Item ID: D3016-041

Item Name: Seat Frame Assembly

DRAWING NO. D3016	TITLE SEAT FRAME ASSEMBLY	REV. A	DART AEROSPACE LTD ENGINEERING ORDER	D.E.O. NO. D3016-A-1	SHEET NO. SHEET 1 OF 1	SCALE NTS
DRAWN	CHECKED <i>(P)</i>	MFG. APPR. <i>PC</i>	APPROVED <i>MAP</i>	DE APPR. <i>-</i>		
DATE 10.01.29	DATE 10.01.29	DATE 10.01.29	DATE 10.01.29	DATE 10.01.29	DATE 10.01.29

**IS:****WAS:****D3016-11 SADDLE****D3016-11 SADDLE**

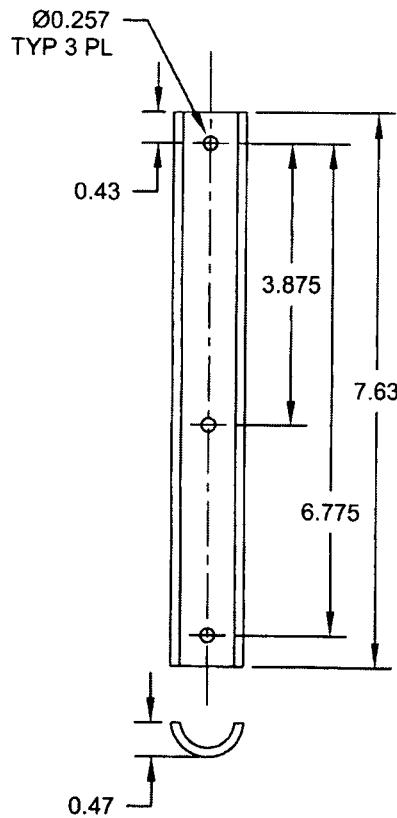
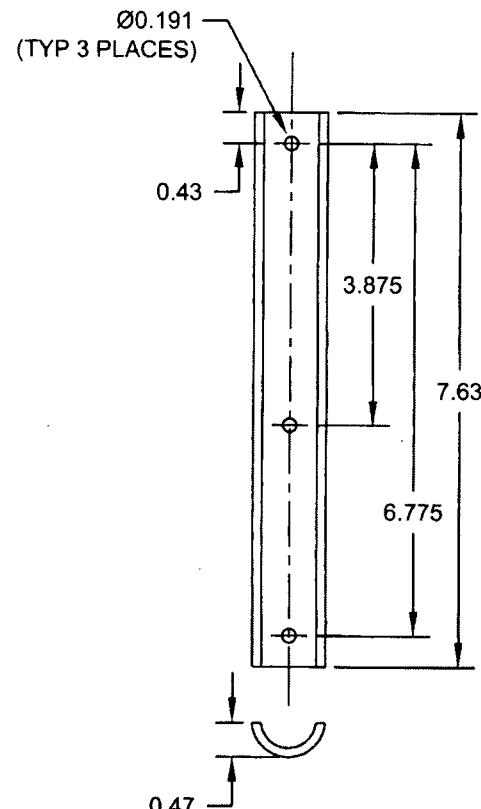
**PURPOSE:**

TO REVISE D3016-11 SADDLE'S HOLE SIZES

DETAIL D3016-11 SADDLE (SHEET 3): Ø0.257 TYP 3 PL WAS Ø0.191 (TYP 3 PLACES) AS SHOWN:
